LOWER MANHATTAN COASTAL RESILIENCY PROJECT – BATTERY

CB1 Environmental Committee Meeting

July 18, 2022

Design Changes

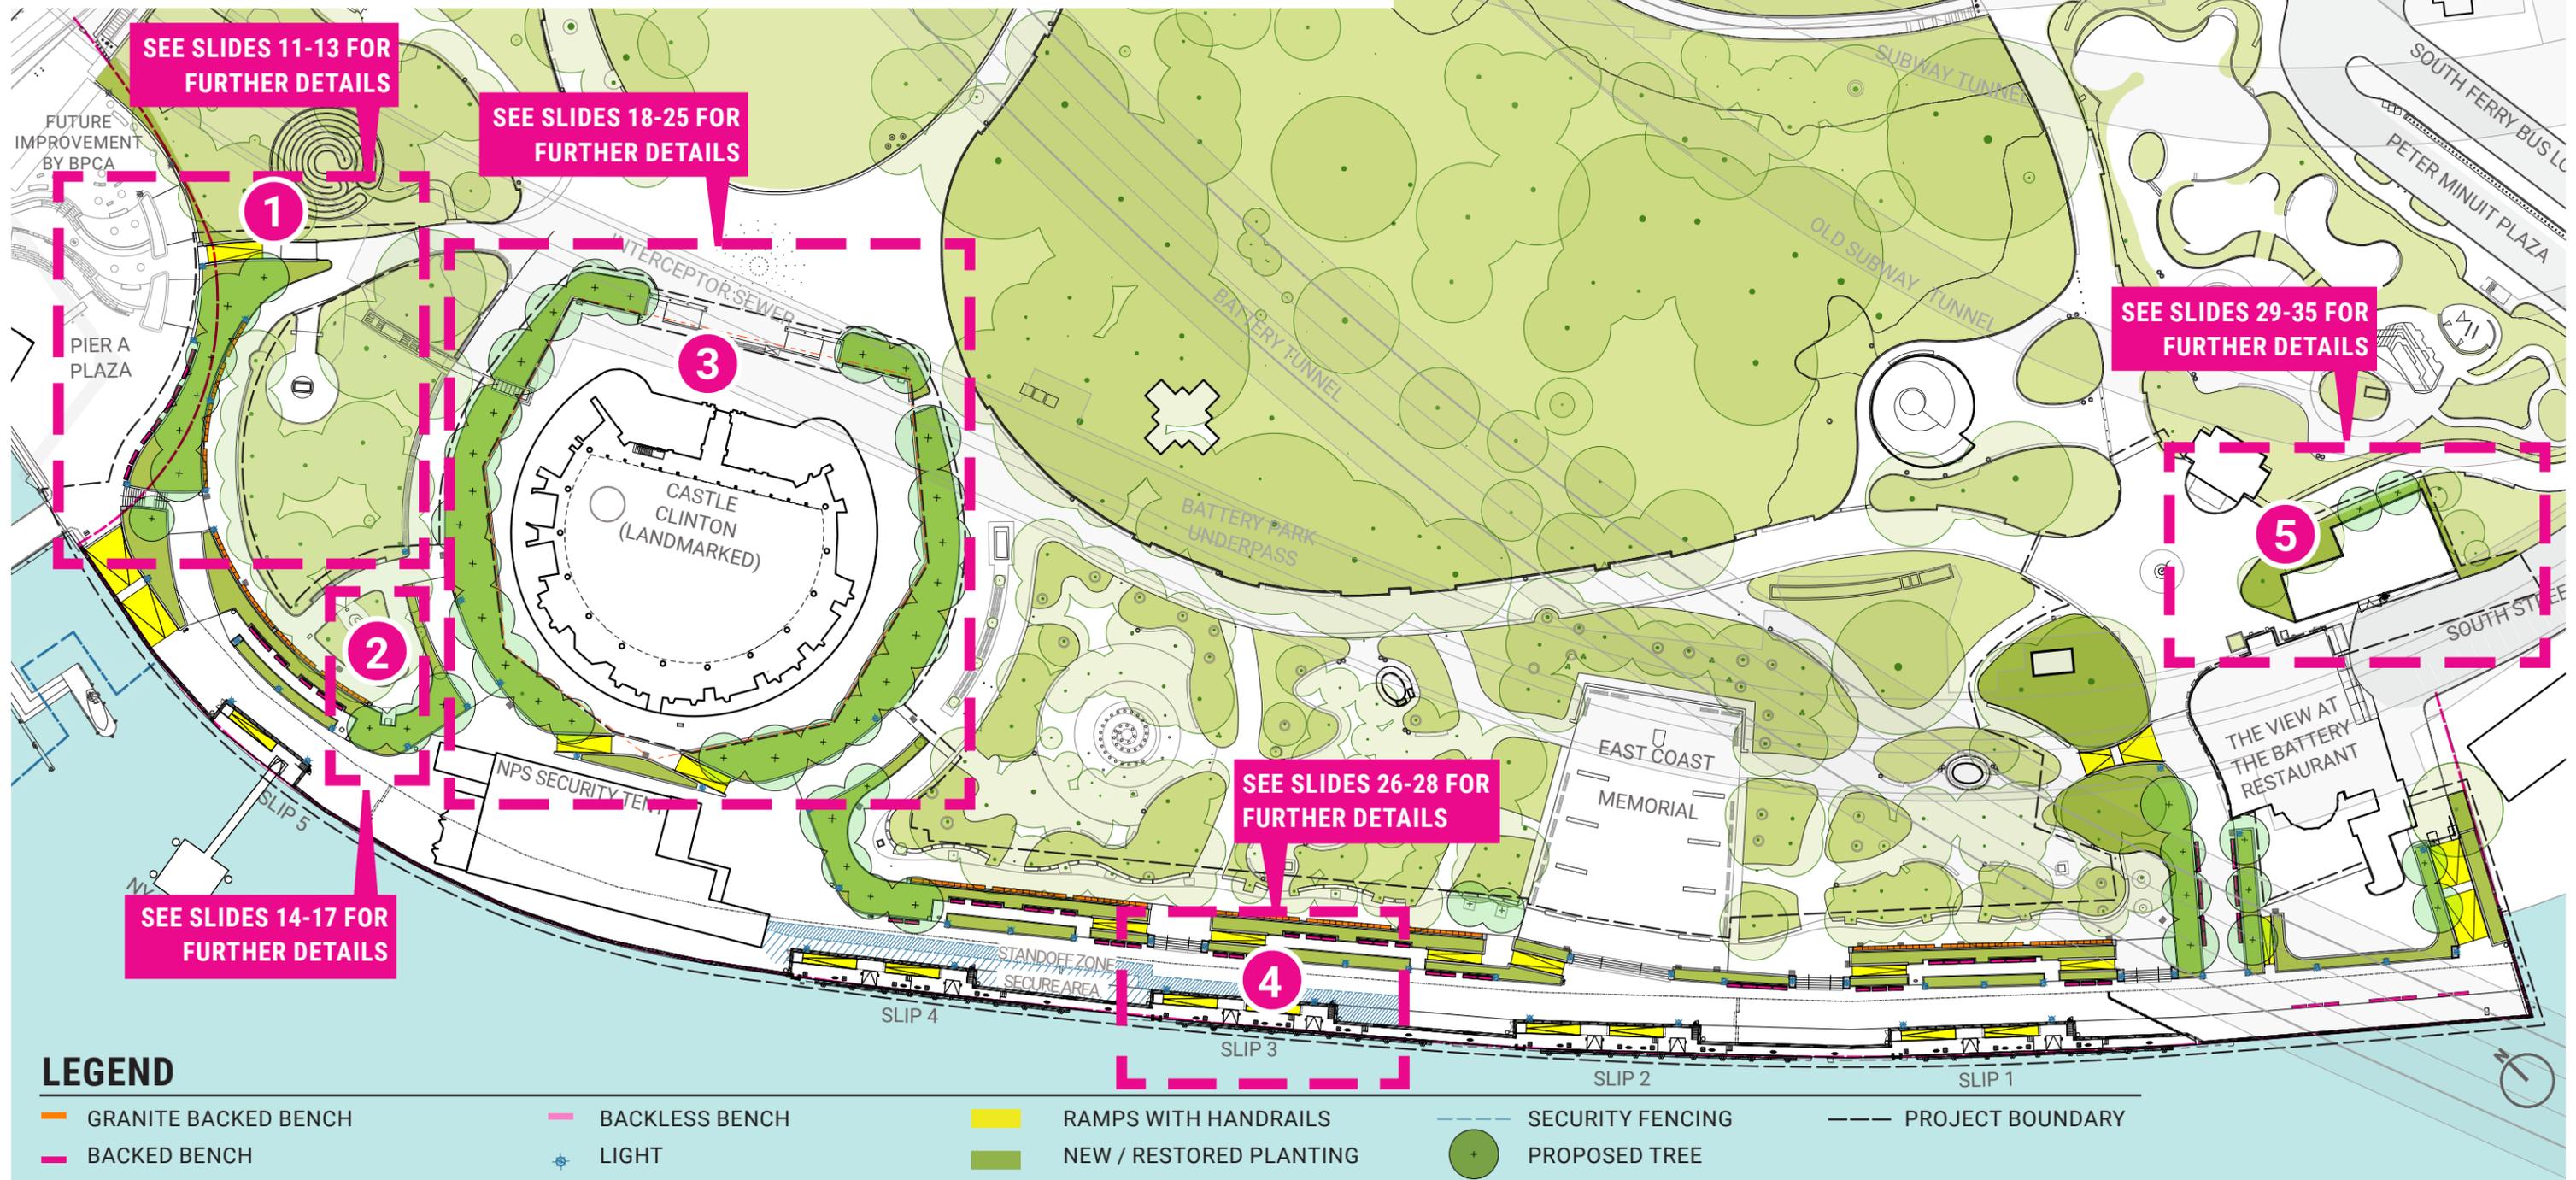
- 1 Pier A ramp connecting to BPCA landing realigned.
- 2 The Emma Lazarus Memorial relocated towards the southwest per request of Parks to help alleviate damage from skateboards and vehicles.
- 3 Four (4) existing London Plane trees and one (1) existing Crabapple tree within the planted area around Castle Clinton will be removed due to poor health, and new planting are proposed for that area. Ramps added to provide better universal access.
- 4 Two (2) light poles have been added at each slip to provide better lighting.
- 5 The M&O area has been further developed to accommodate Parks' needs.

Emma Lazarus Memorial Relocation

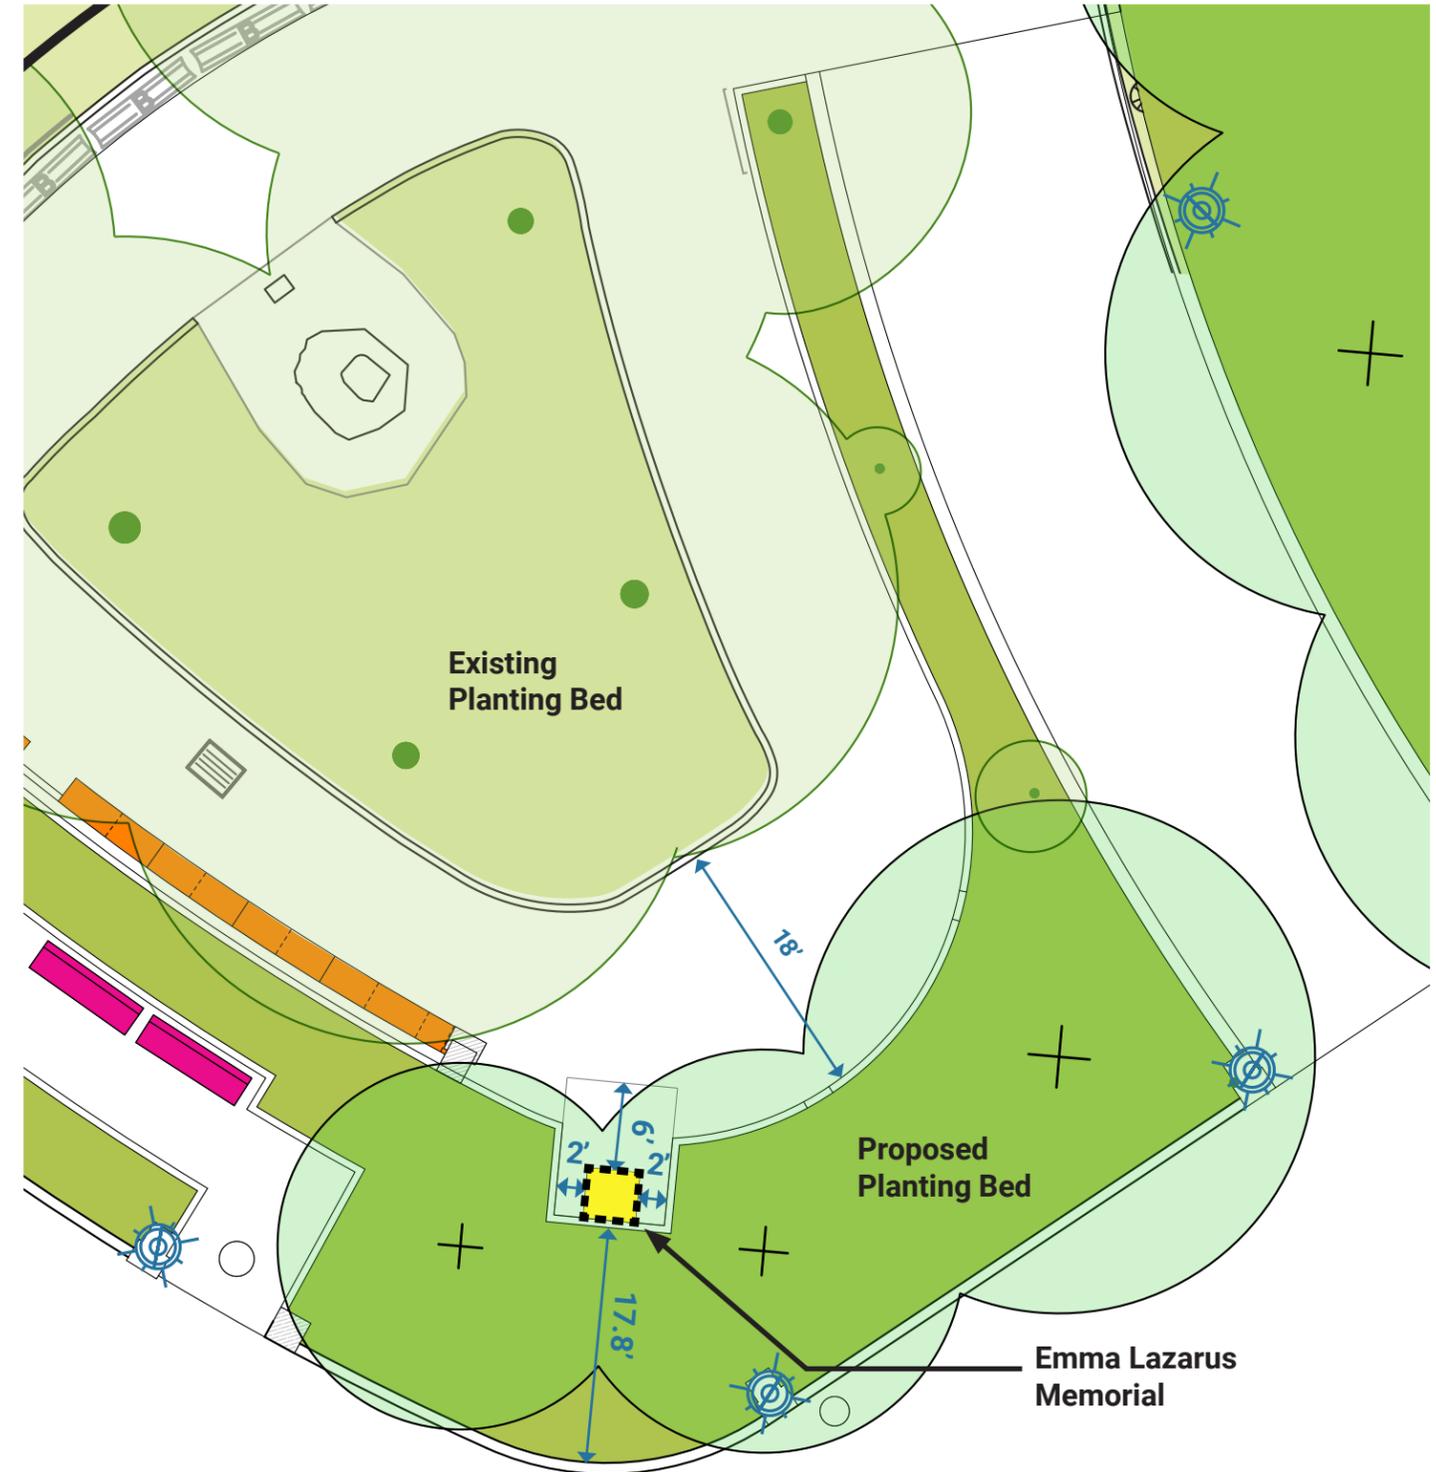
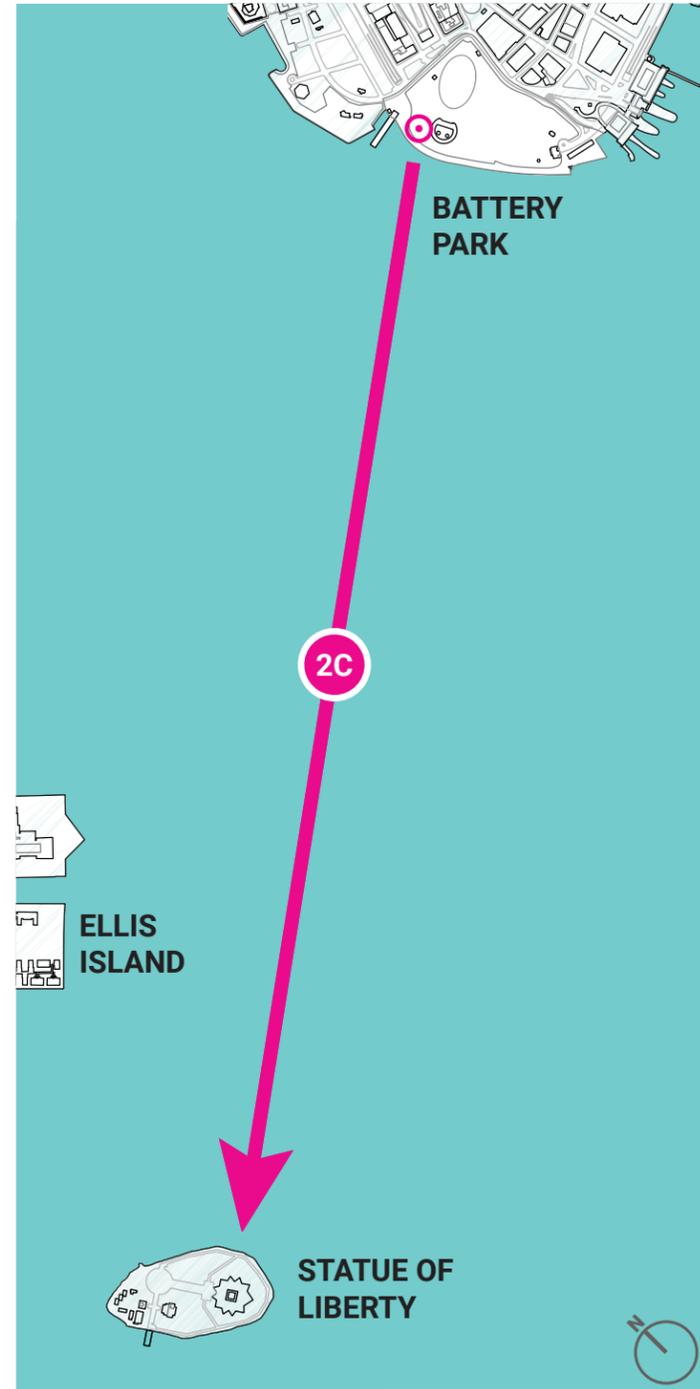
- 2A** The Emma Lazarus Memorial has been relocated towards the southwest per request of Parks to prevent damage from skateboards and vehicles
- 2B** The memorial is protected by planting on three sides.
- 2C** The proposed location has a direct view of Statue of Liberty in its background.

Existing Castle Clinton Planting

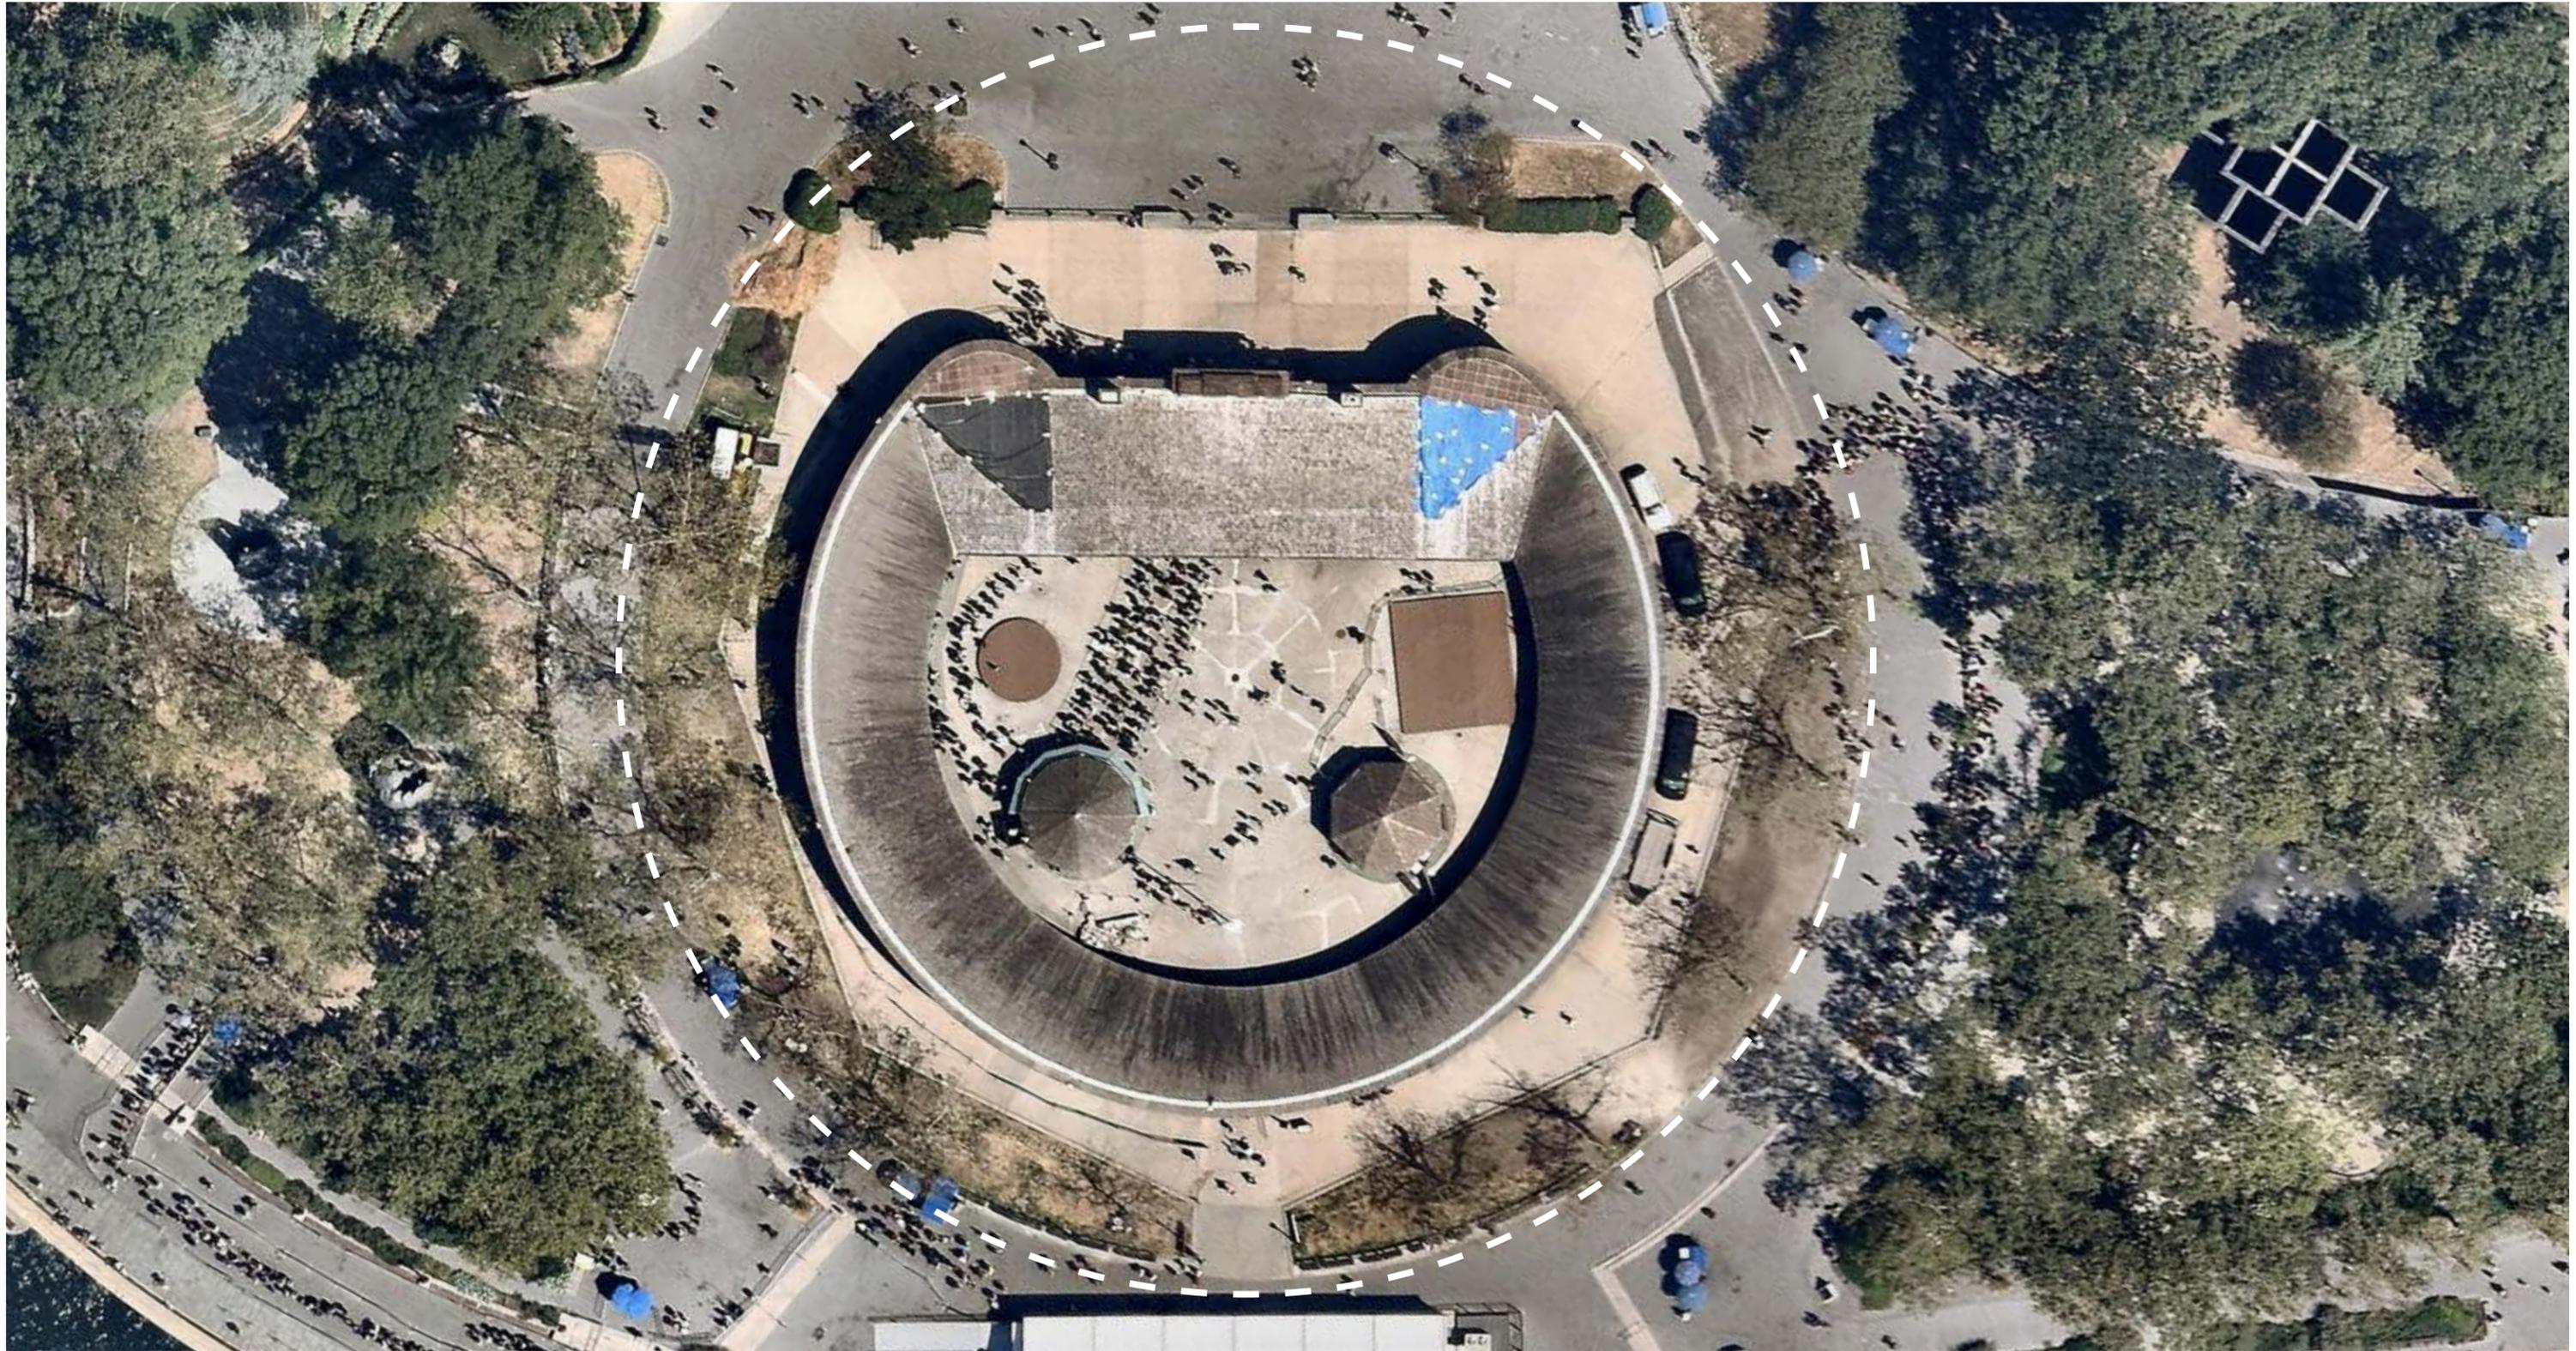
- Without trees there would be a lack of shade in this dashed area
- Four (4) existing London Plane trees and one (1) existing Crabapple tree within the planted area around Castle Clinton will be removed due to poor health, and new plantings are proposed for the entire plant bed around Castle Clinton

Site Plan for M&O Area

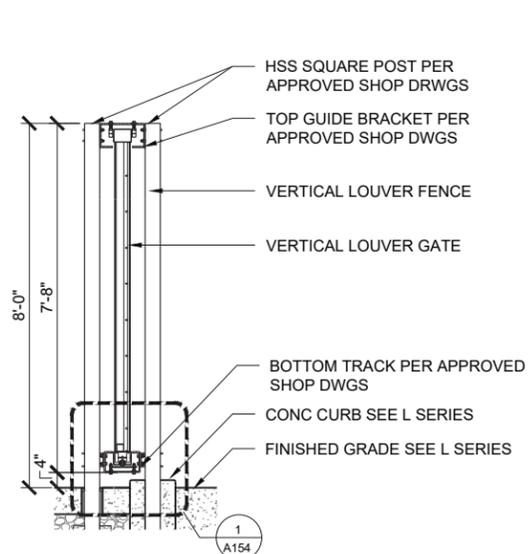
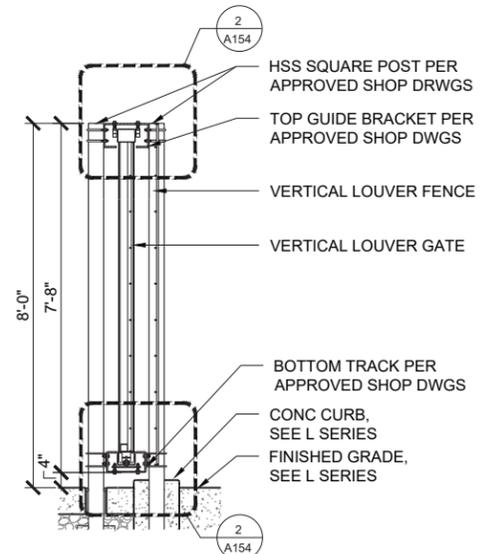
- 5A** Adjustment of the footprints of the paved area and surrounding planting
- 5B** Further development of the fence and gate design materials

- Tree #332 removed to provide additional space for M&O area
- New pavement minimizes impacts to CRZ's to provide more M&O space for operations
- Pavement installed at existing beer garden elevation to reduce impacts to trees (drop curb located at gated entrance)
- Paved area will provide secure space for DPR M&O storage containers and vehicles, all of which are fence height or lower.
